Information of the small P.C.Board

Schematic Diagram of the small P.C.Board

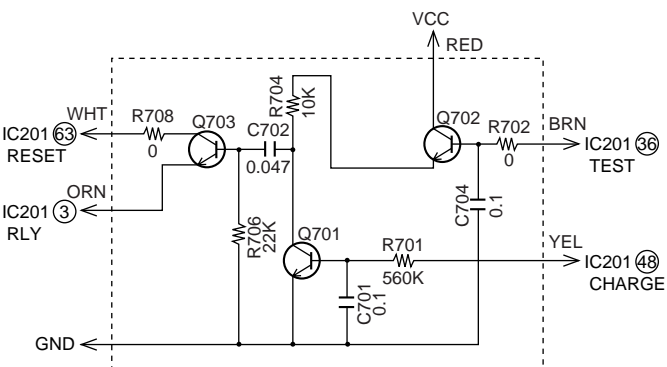
Suffix A: Produced with small P.C.Board for countermeasure to inferior Linking caused by old CPU.

Suffix B~: Improved CPU (part No.: MN150832BB1)
and deleted small P.C.Board.

1. Only improved CPU (part No.: MN150832BB1) is supplied as replacement parts.
2. It is possible to replace old CPU of base unit with small P.C.Board to improved CPU (part No.: MN150832BB1).
